Access Compliance Report

Public Rights-of-Way

| Intersection ID: 19443 | Main Street: ECHODALE_DR | Cross Street: ELLENDALE_DR | Location: NE |
| ADA ID: 581842615298 | Ramp Type: Directional1 | Initial Pass/Fail: Fail | Overall Compliance: No |

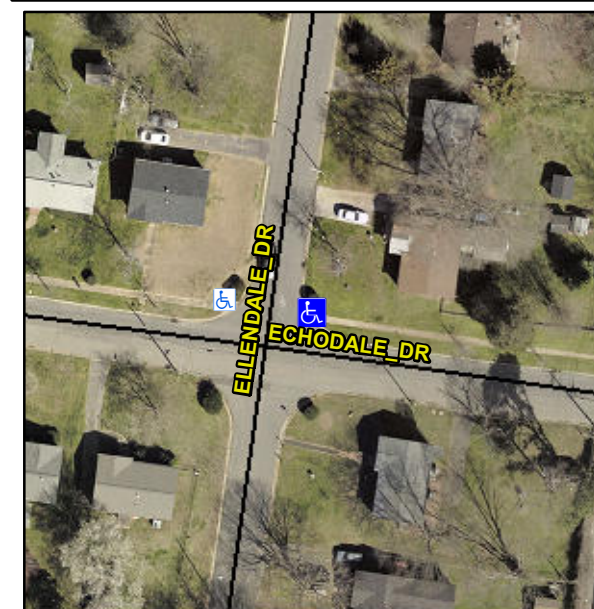
| Severity Score: 33.75 | | | |

R304.5.1, R304.5.3

| Compliance | Description | Data | Compliance | Description | Data |
|------------|-----------------------|------|------------|-----------------------------|------|
| No | Ramp Width (in) | 38.0 | N/A | Grade Break Slope (%) | 0.0 |
| No | Ramp XSlope (%) | 7.2 | | | |

Remove & Replace Entire Ramp.
